IT15120830

Hassen f.r.

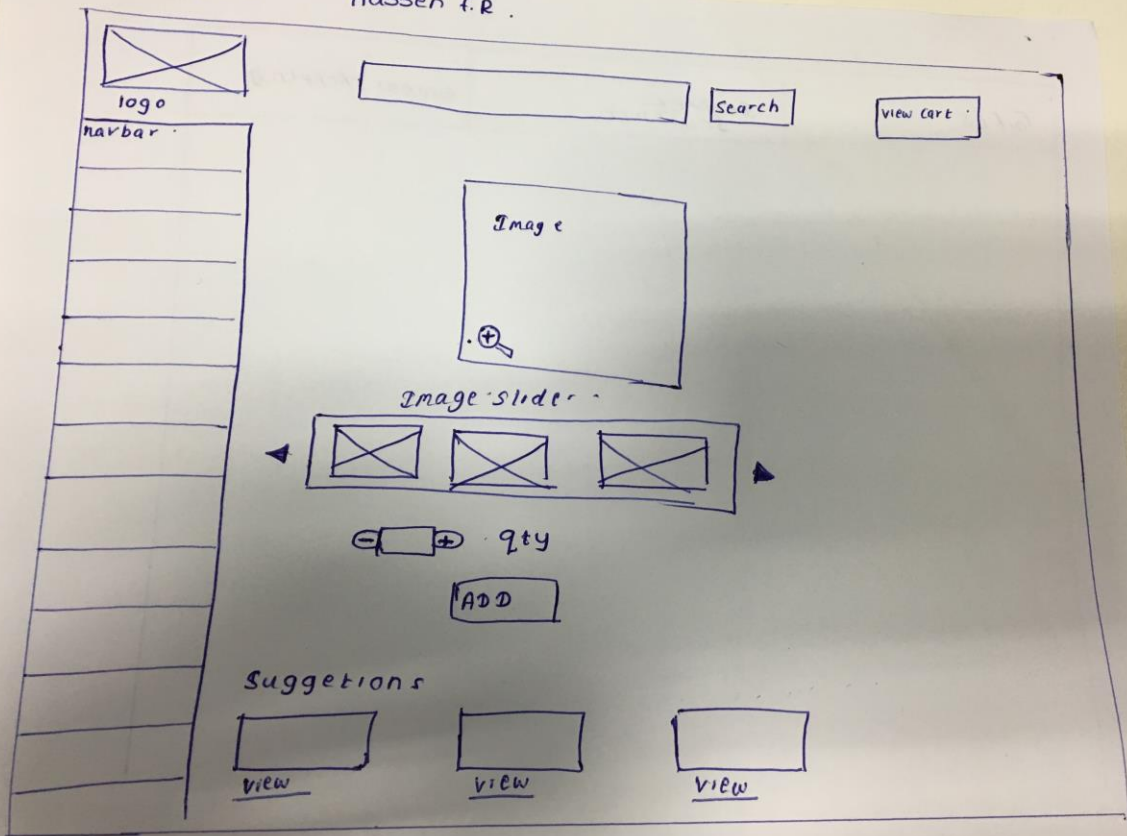
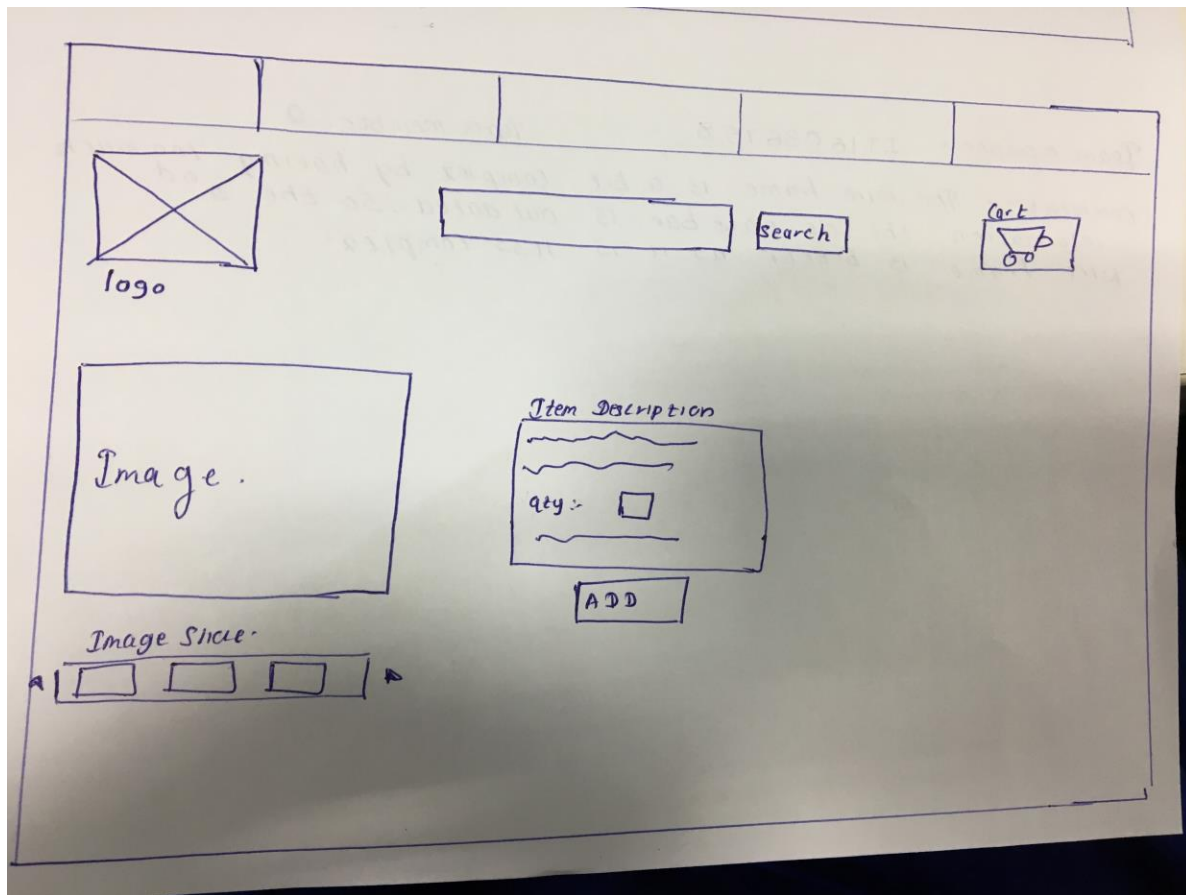
Comment :- The wire frame is a bit complex by having too much information. the side nave bar is outdated. So the 2<sup>nd</sup> wire frame is better as it is less complex.
